### DEPARTMENT OF ECOLOGY

MEMORANDUM March 20, 1979

Subject: Spokane Industrial Park Class II Inspection

Figure 1 SPOKANE INDUSTRIAL PARK

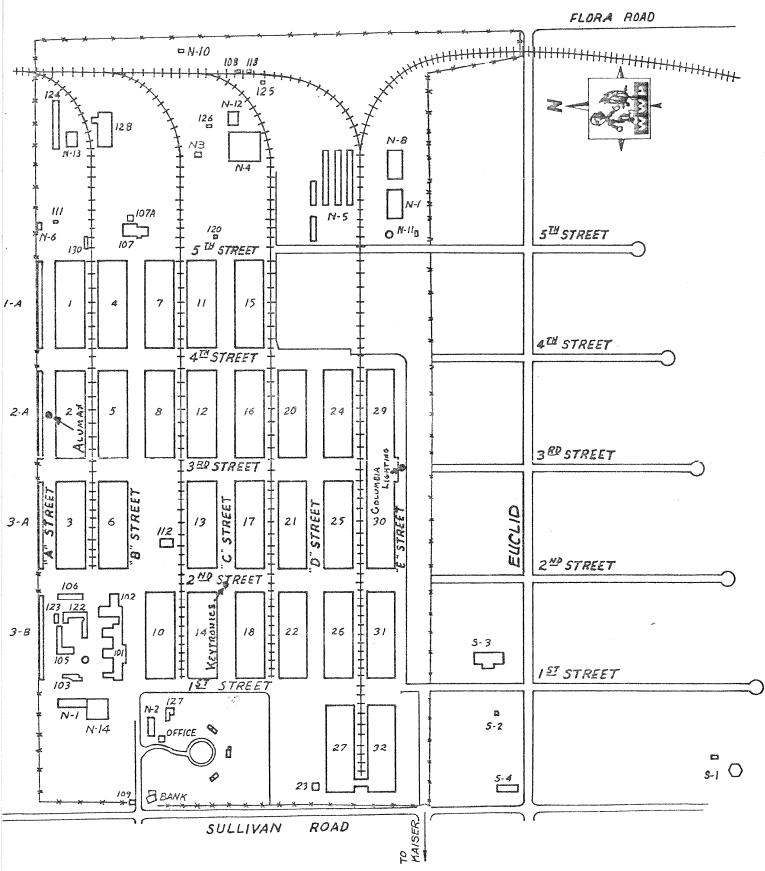
In conjunction with this inspection, grab samples were taken for a number of parameters at three manholes at the SIP. The manholes accessed sewers serving Keytronics, Columbia Lighting, and Alumax, and are illustrated in Figure 1. It should be noted that the flow in the Alumax manhole was very low and that Alumax may not have been discharging at the time of collection. These samples were analyzed primarily for trace metals and other toxic substances including cyanides and phenols (Table 3). The treatment plant influent and effluent were sampled for the same parameters (Table 1). The concentrations of these substances which are potentially harmful to both SIP biomass and receiving water organisms are compared with values obtained at municipal plants throughout the state and threshold values for nitrification and carbonaceous removal inhibition in Table 3. Copper, lead, and nickel concentrations at the SIP are much higher than those at typical municipal treatment plants. Copper, lead, and zinc concentrations are above those which may result in microbial inhibition. Results indicate that Keytronics is a major source of copper, lead, and nickel. The Alumax manhole sample had a high zinc concentration but flow at this manhole was low and it is not known if Alumax was discharging at the time samples were taken. Clayton Repp indicated that Keytronics is planning to put in a pretreatment system but the nature of this system was not known.
